Magnolia Public Schools

Ad-Hoc (Facility) Committee Meeting

Approval of Change Order Requests by Oltmans Construction Co. for MSA-1

Ad Hoc Committee Agenda Item #:	II A – Action Item
Date:	January 23, 2020
To:	Magnolia Educational & Research Foundation dba Magnolia Public Schools (“ MPS ”) Ad Hoc Committee (the “ Committee ”)
From:	Alfredo Rubalcava, CEO & Superintendent
Staff Lead:	Patrick Ontiveros, General Counsel & Director of Facilities
RE:	MSA-1 Change Order Requests

City of Los Angeles
Department of Building and Safety

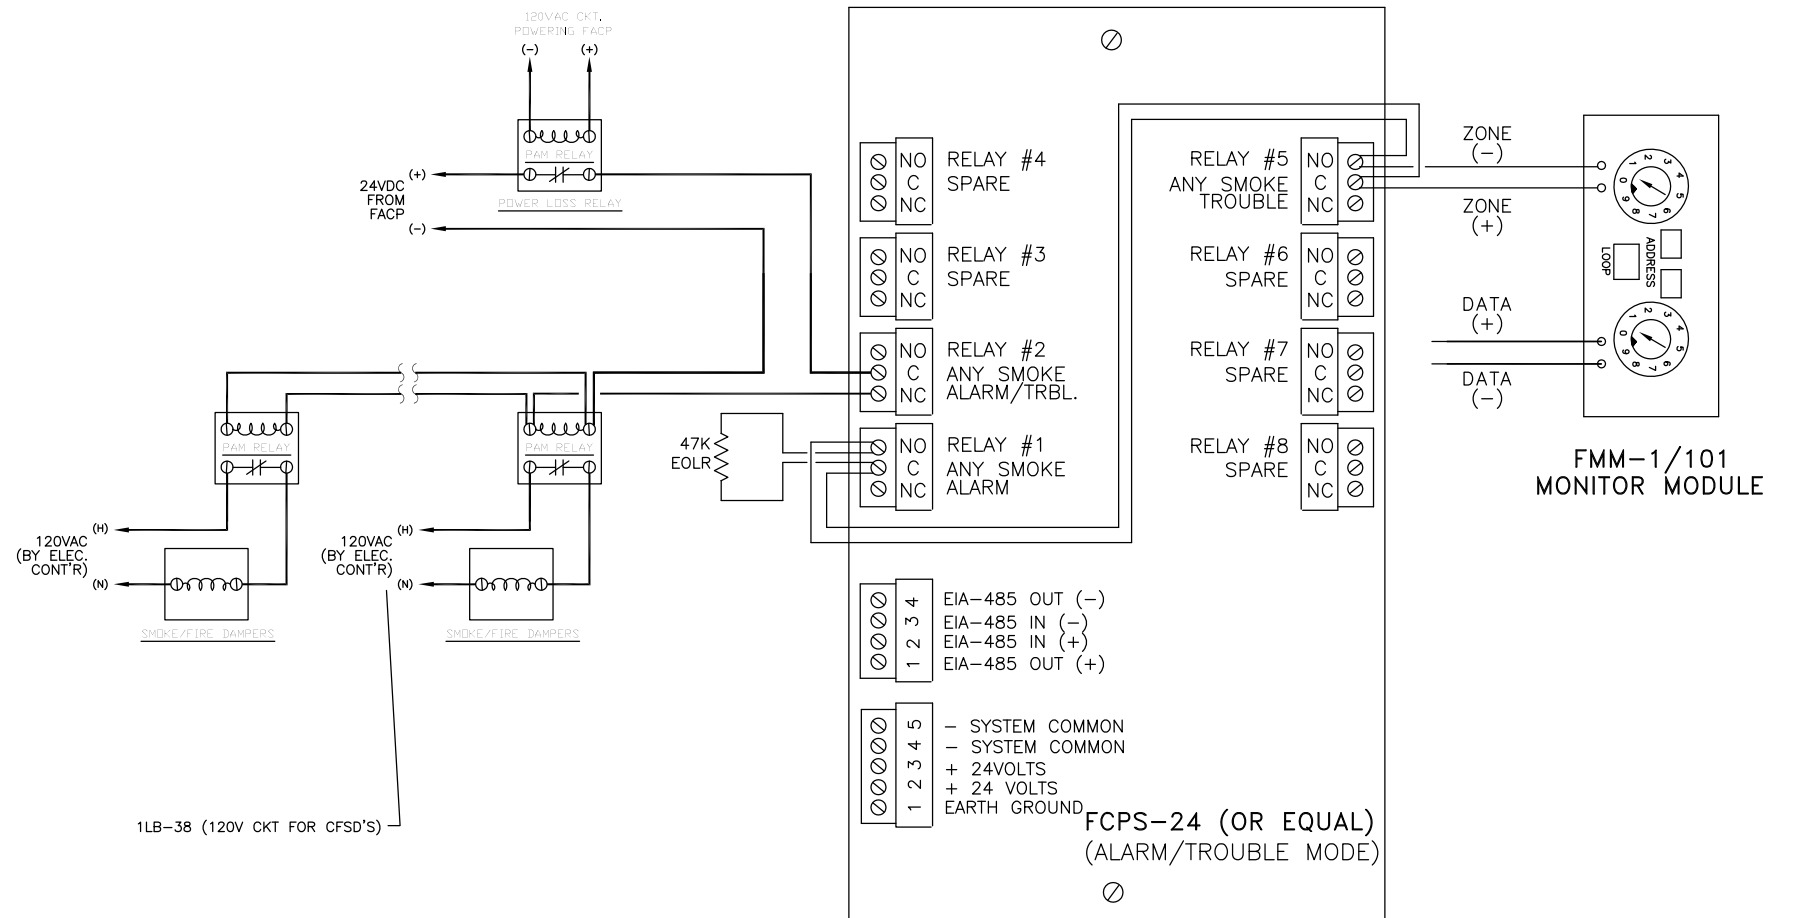
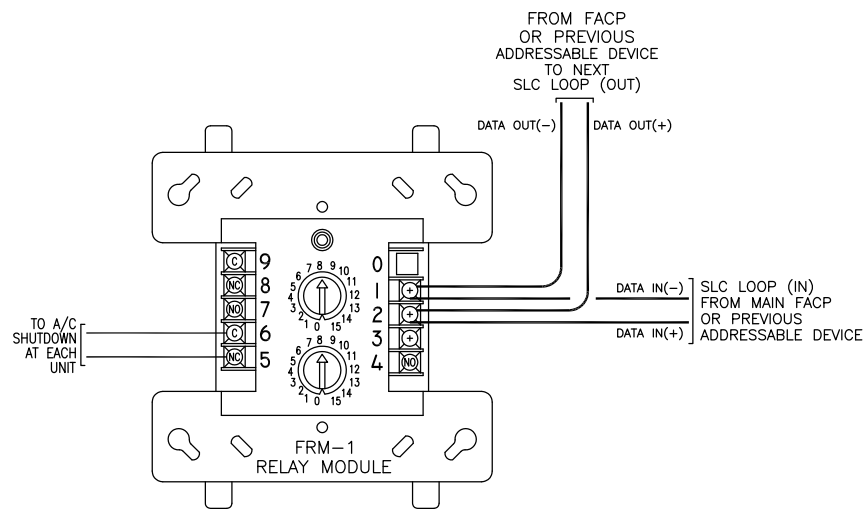
JOB ADDRESS: 18220 W SHERMAN WAY			PERMIT #: 17044-20000-07122	CONFIRM #: 25305989
JOB DESCRIPTION: HVAC			FOR REINSPECTION CALL: (888)LA4-BUILD or 311 INSPECTOR: KEVIN BROWN DISTRICT: HVACVN1 PHONE: (818) 374-1153 BUREAU: Inspection Bureau DATE: 8/13/2019	
APPLICANT/AGENT: CHRISTIAN BROTHERS MECHANICAL SERVICES INC				
ADDRESS: 11140 THURSTON LANE				
CITY: MIRA LOMA	STATE: CA	ZIPCODE: 91752		
<p>Before the work or installation authorized by this permit can be approved, concealed, energized, or used, the following deficiencies shall be corrected. Call for reinspection when all corrections have been made.</p>				
<p>PERMIT GROUP/TYPE/SUBTYPE: Mechanical/HVAC/Commercial INSPECTION TYPE: VENTILATION-Final</p>				
<p>VIOLATION NUMBER: 19-DMN-141-G-3346 Date Issued: 8/14/2019 Issued by</p> <p>VIOLATION TYPE: LAMS Smoke/Fire Damper Smoke Detection</p> <p>VIOLATION CODE SECTION: 95.606.1 LAMC</p> <p>CODE LANGUAGE: Provide duct detector within 5 feet of each smoke/fire damper in the airstream or provide full area coverage (716.3.2.1 CBC).</p> <p>VIOLATION NOTES: Second</p>

<p>VIOLATION NUMBER: 19-DMN-141-G-3410 Date Issued: 8/14/2019 Issued by</p> <p>VIOLATION TYPE: Fan Shutdown</p> <p>VIOLATION CODE SECTION: 95.609.0 LAMC</p> <p>CODE LANGUAGE: Provide duct detector in the main supply air plenum of all air moving systems in excess of 2000 CFM combined, such systems shall shutdown simultaneously without delay.</p> <p>VIOLATION NOTES: Second</p>

1 WEST WALL

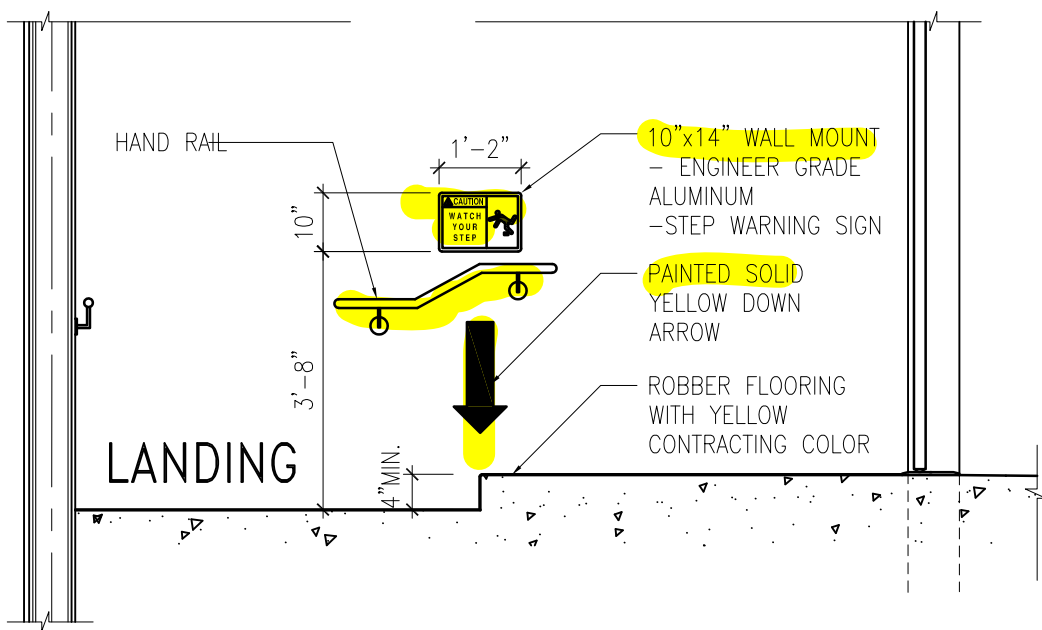
1. OCCO is to provide a color change at landing (stair #2, roof top only) due to added step. Such as warning tape or tread cover in safety yellow or contrasting color.
2. Add a small railing (on the wall side) by landing step, due to added step (stair #2, roof top only) .
3. Adjust hand railing at the landing due to added step (stair #2, roof top only) on the previously approved shop drawing 051200-03 Stairs Shop Drawings FAC 071018.

Add hand rail & backing per jobsite walk after OAC 5/8/19.

Change hand rail & backing per jobsite walk after OAC 5/8/19.

2 EAST SIDE RAIL

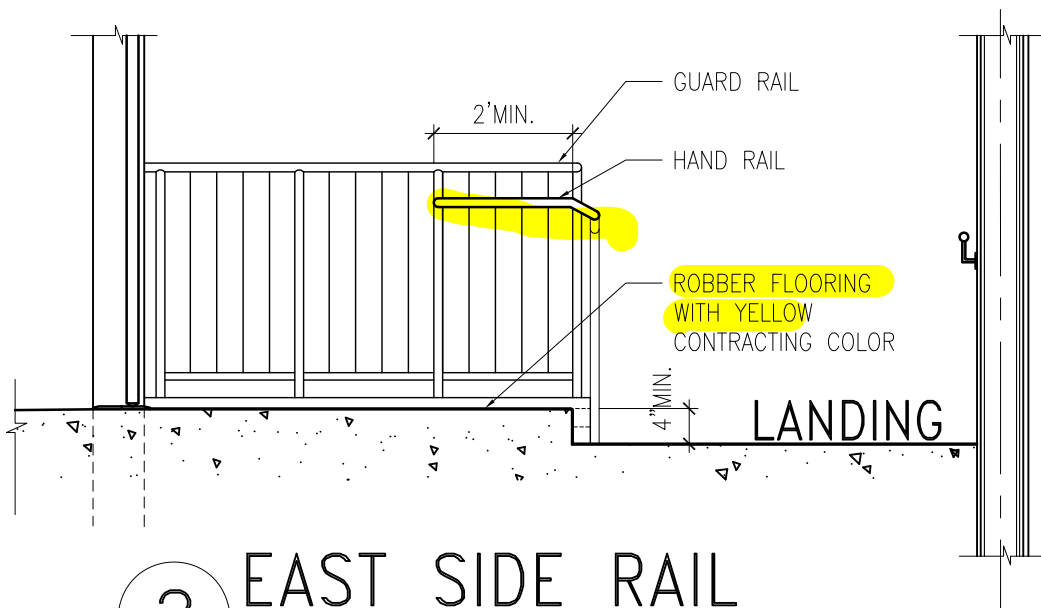
Watch-your-Step-Sign AVAILABLE AT:
www.mysafetysign.com/Trip-Fall-Signs/Watch-your-Step-Sign/SAF-SKU-S4430.aspx
 OR APPROVED EQUAL

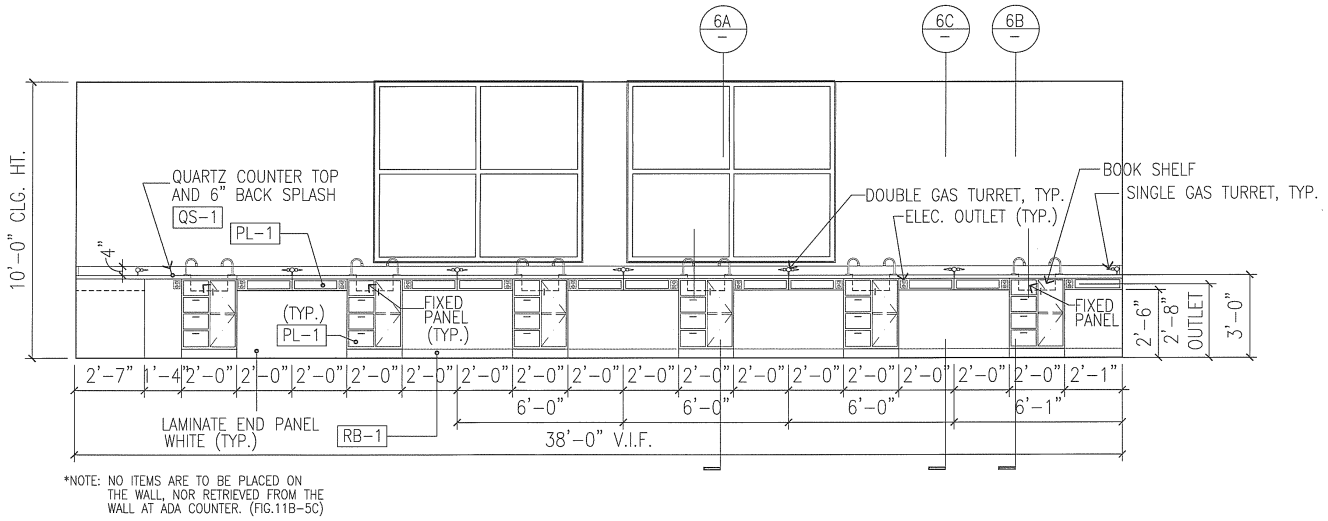
The Chemistry Lab room #201 has full height windows facing North above the lower cabinets. See A9.3 detail 8. The windows are type "A" found on A10.1. The plumbers have no way to run their waste and vents. We have large structural beams above and below. The 18" cavity between the windows are full of structural posts etc. There is no room to run a vent or waste up or down this 18" cavity.

Adjust the cabinet work at the north-west corner.

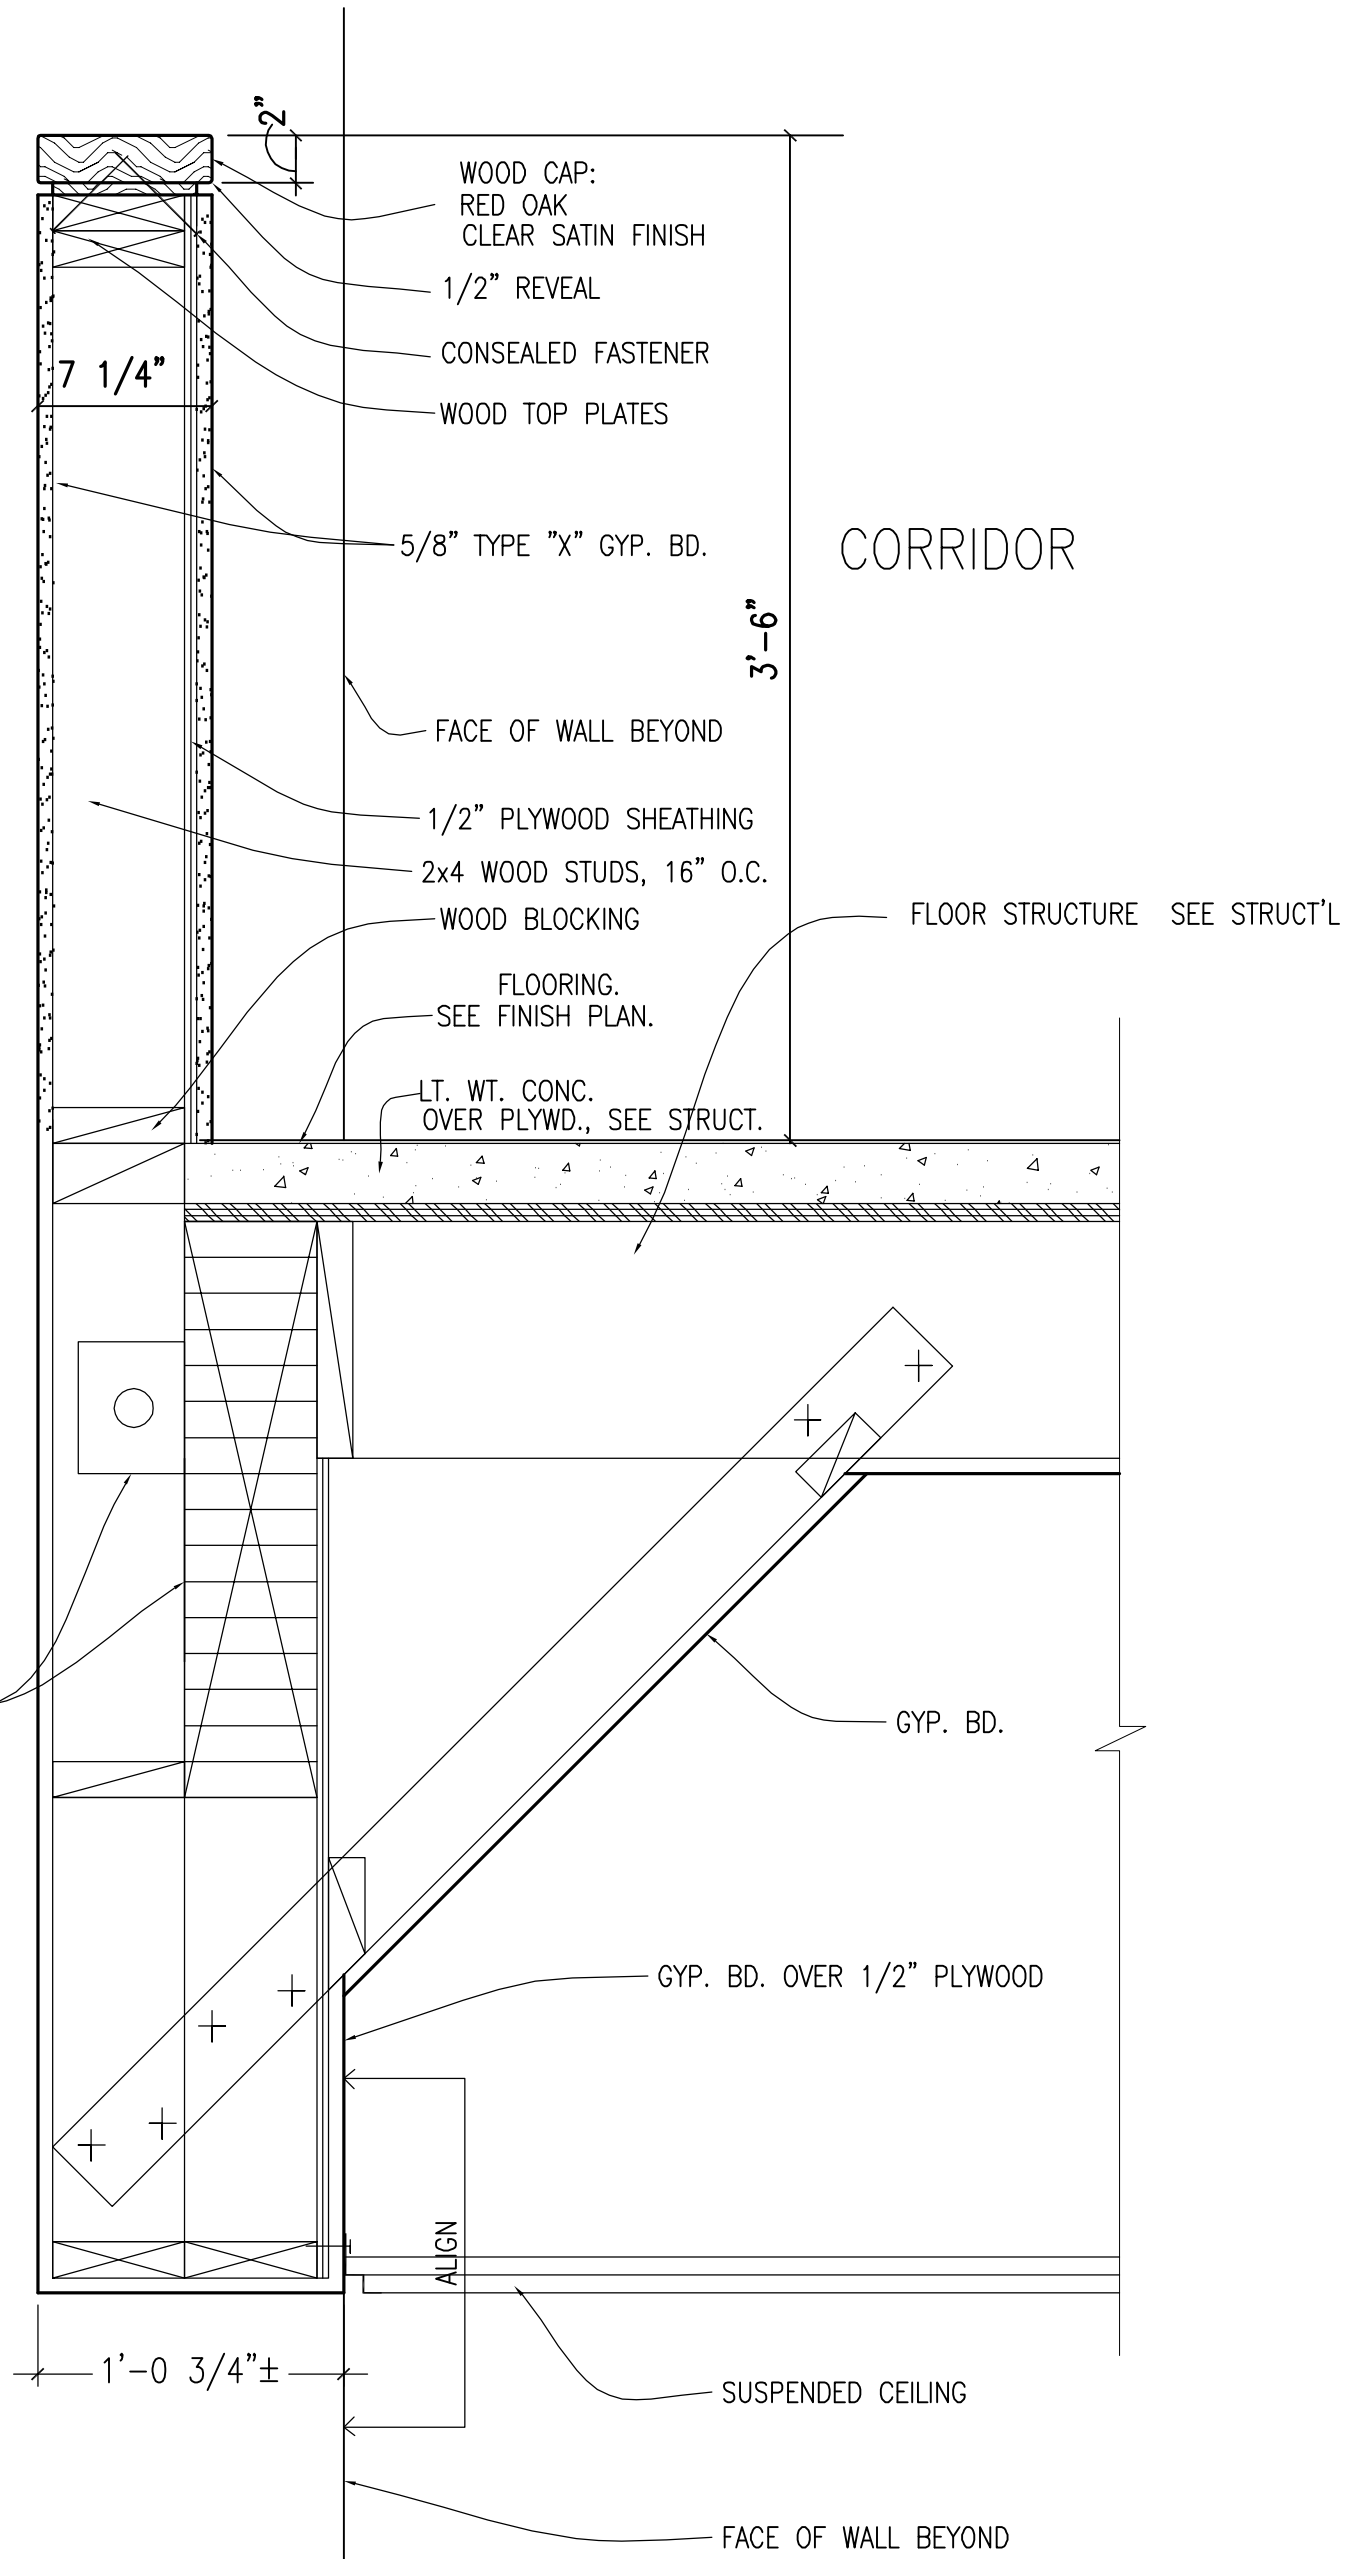
As discussed with Johann at job walk 3/20/19: At 2nd floor 2/ A6.2 shows the low wall on top of the beam; this is the incorrect detail. Sheet S6.3 detail 11 shows the low wall / curtain wall bolting to the beam; this is the correct detail we followed. The bottom of the curtain wall needs to be widened by 6". Please confirm.
